Subject ► Change on the Bolt to Fasten the Stopper Base

For Models ► 6830 and 6832 (Auto-feed Screwdrivers)
6831D, 6831DWH, 6831DWA (Cordless auto-feed screwdrivers)

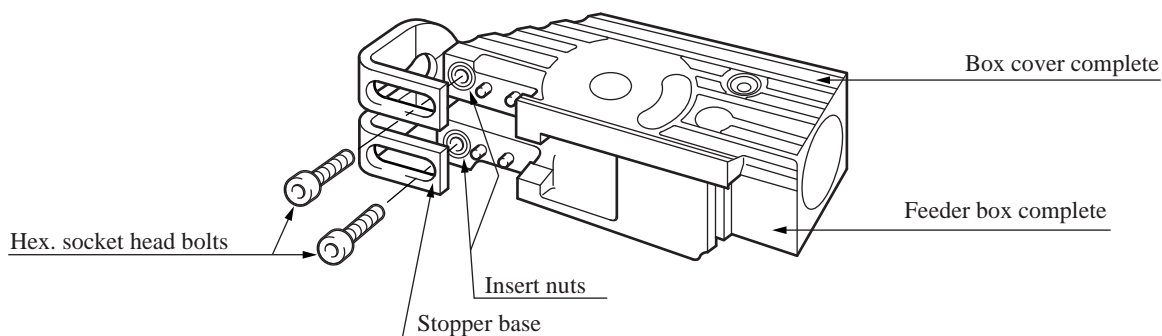
► Current	► New
Fastening bolt	Hex. socket head bolt M4x8	Hex. socket head bolt M4x18
<p>•The longer fastening bolts prevent the insert nuts from getting loose and keep the stopper base fixed more firmly to the feeder box complete and the box cover complete. Accordingly, the machine is kept square more accurately against the workpiece.</p>

Item No.	Current part		Q'ty	I/C	New part		Q'ty	Note
33	Hex. socket head bolt M4x8 922107-1		2	<=	Hex. socket head bolt M4x18 922132-2		2
